**Planned Unit Development – Lot 3 Southport East
Replat Six; 8040 Eastport Parkway – Hausmann
Holdings, LLC**

**CITY OF LA VISTA
PLANNING DIVISION
RECOMMENDATION REPORT**

CASE NUMBERS: PPUD24-0001;

RE: Hausmann Construction Office Building Planned Unit Development
Initial Review Letter

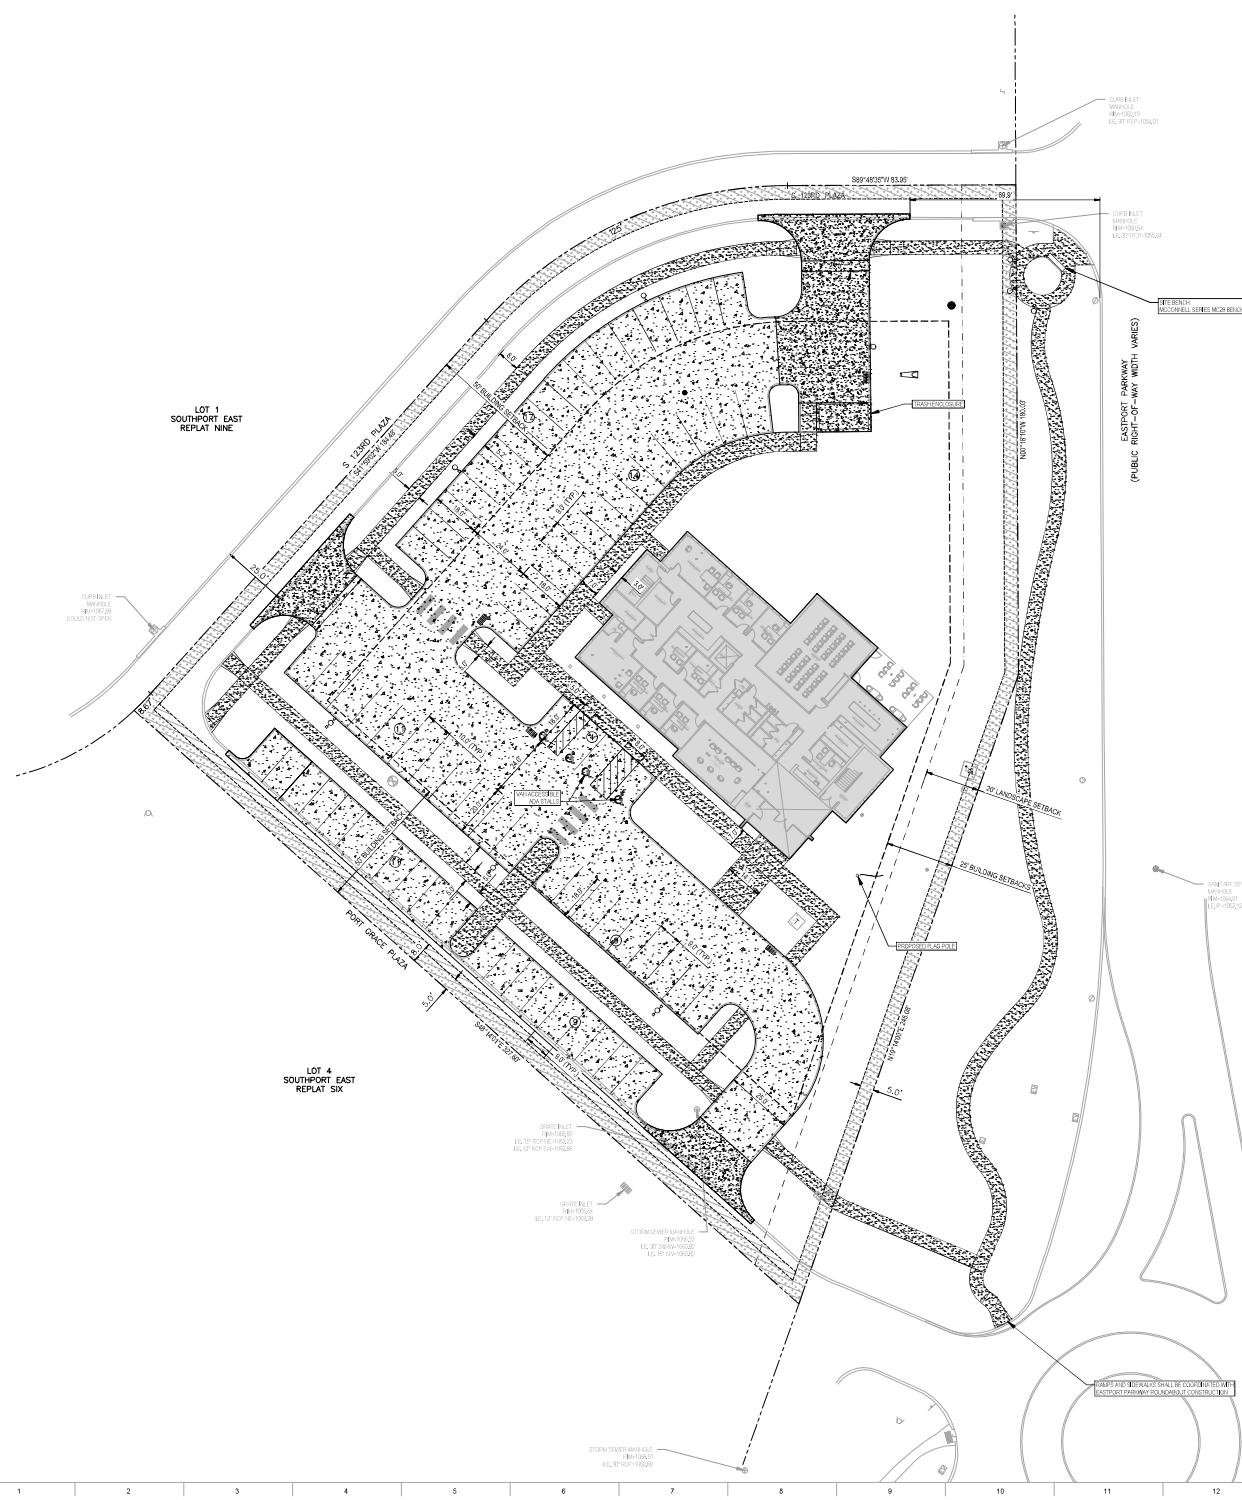
13. We recommend relocating the dumpster enclosure to the northeast corner of the property to move it further from the travelway edge and the entrance of the building, as noted in the attached redline site plan. Please confirm the waster hauler truck routing and turning movements are acceptable to properly service the trash enclosure.

14. Please include a sidewalk ramp for the sidewalk on the west edge of the property that directs toward Lot 1 Southport East Replat 9, and confirm that the alignment does not conflict with the storm sewer inlet on the other side of the street, as noted in the attached redline site plan.

Response: Dumpster enclosure has been relocated to the northeast corner of the property.

Response: A ramp directed towards Lot 1 Southport East Replat 9 has been added. The alignment does not conflict with the storm sewer inlet on the other side of the street.

5 of 6

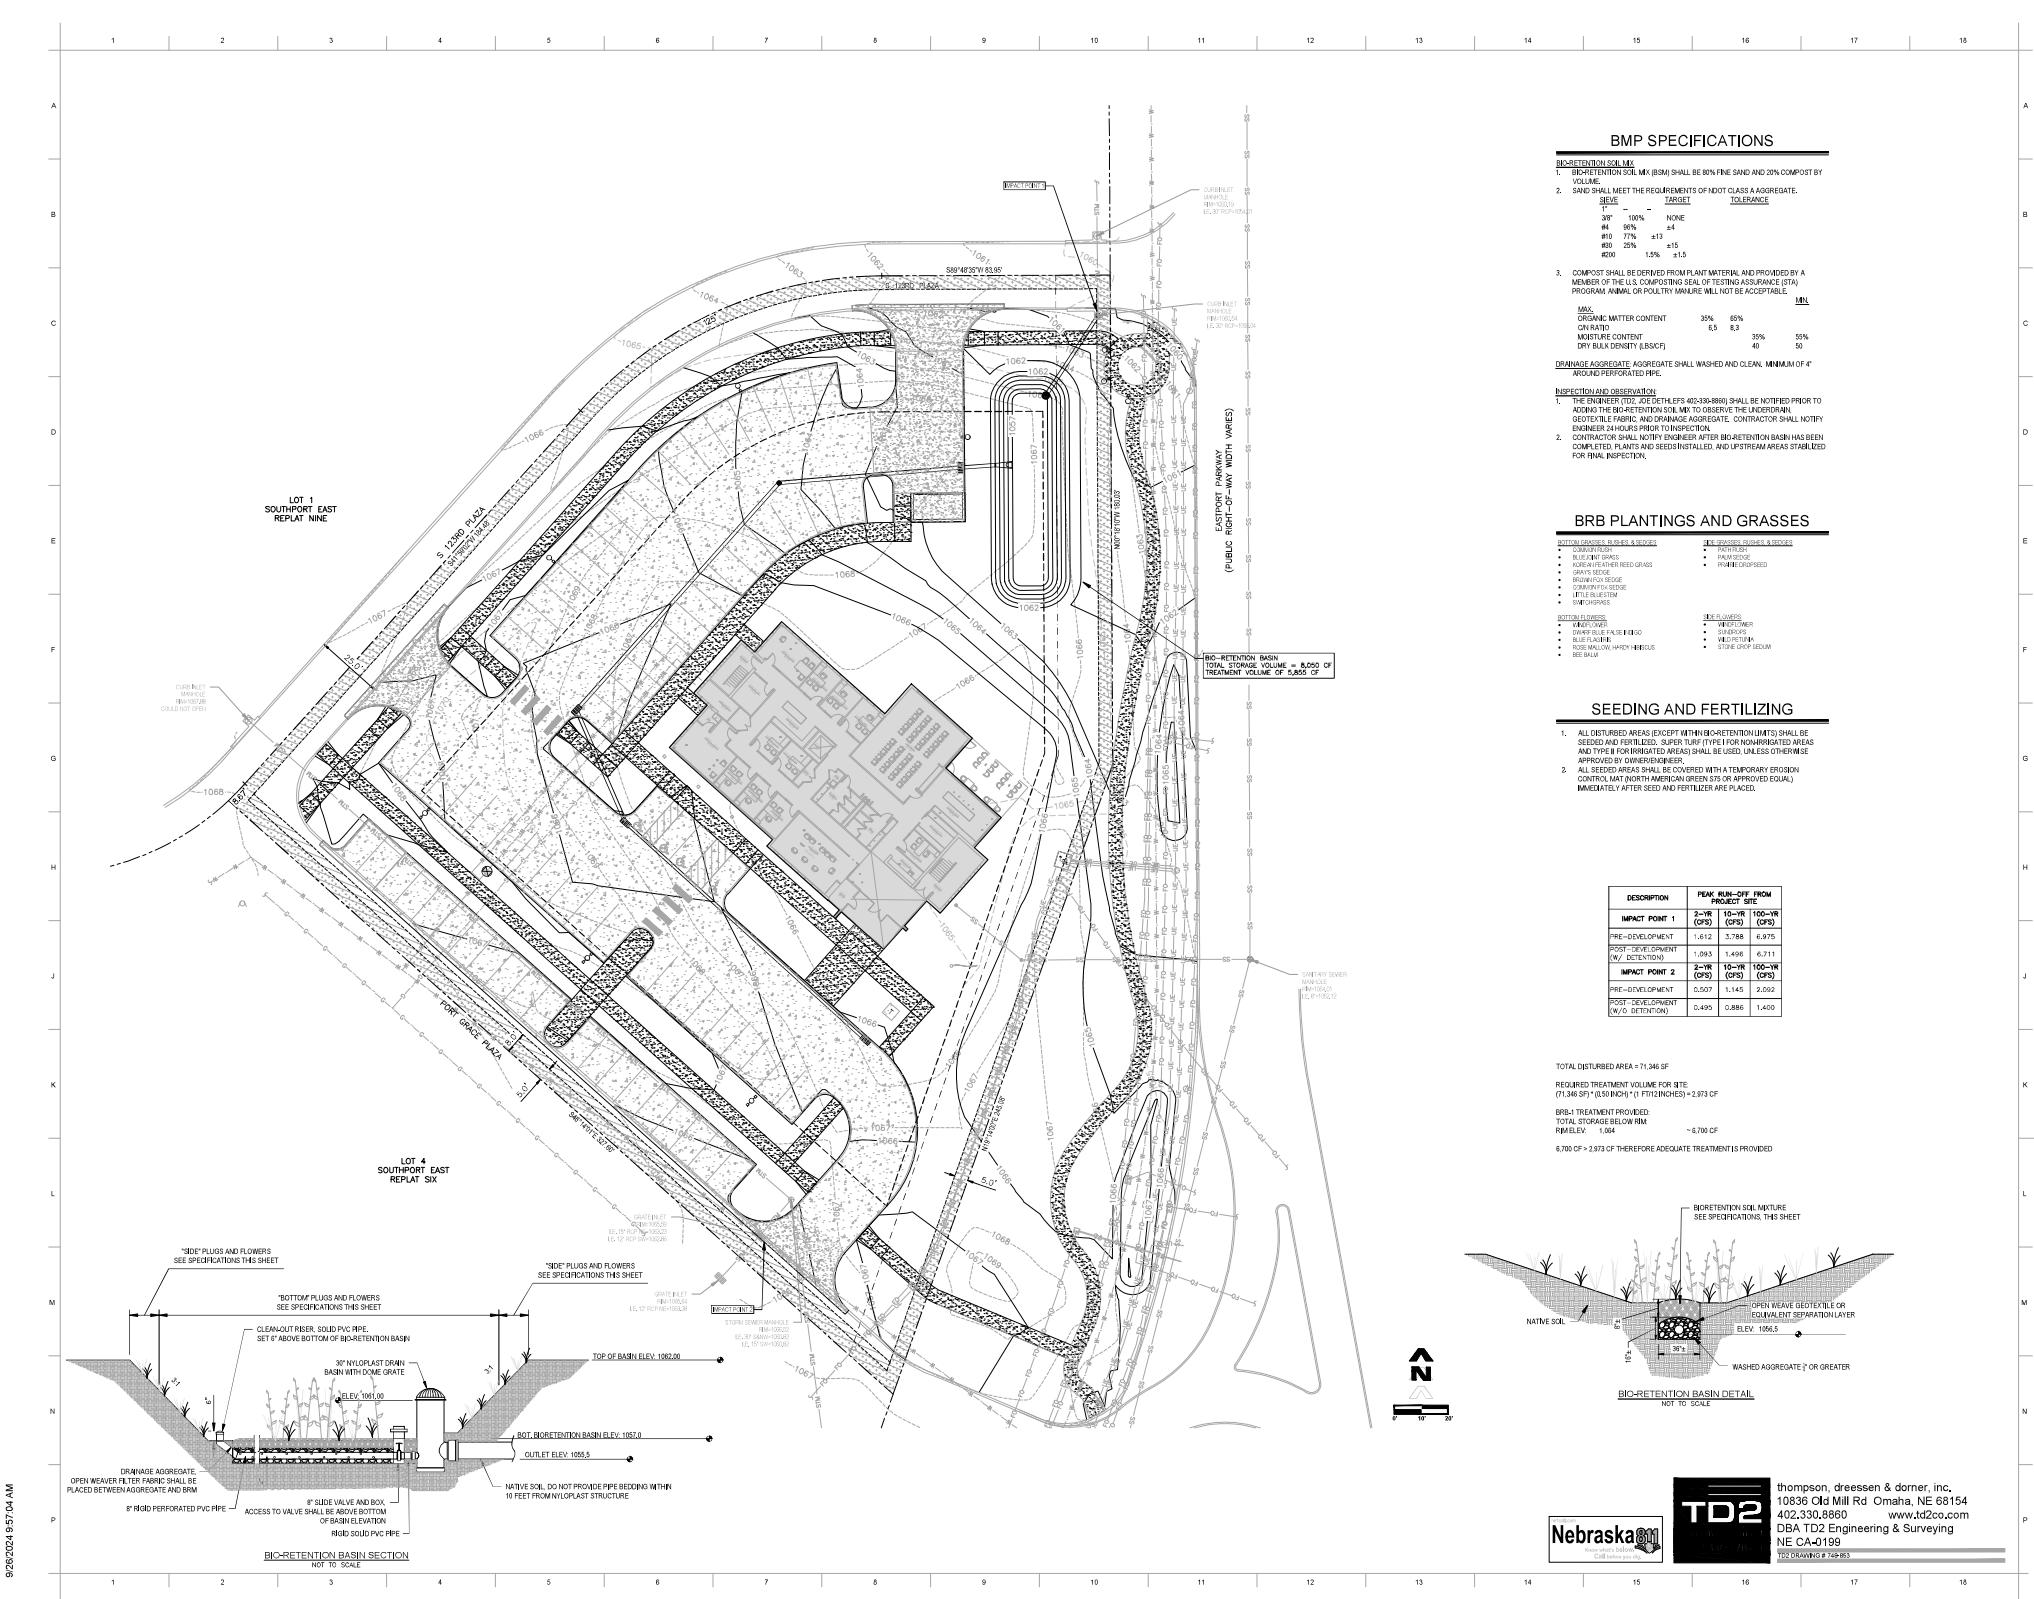
5. Per Section 5.15.05.04, please include the calculations for the pre and post development 100 year events on the Post Construction Stormwater Management Plan Sheet (Sheet 5 of 6).

Response: The 100 year event has been added to the table.
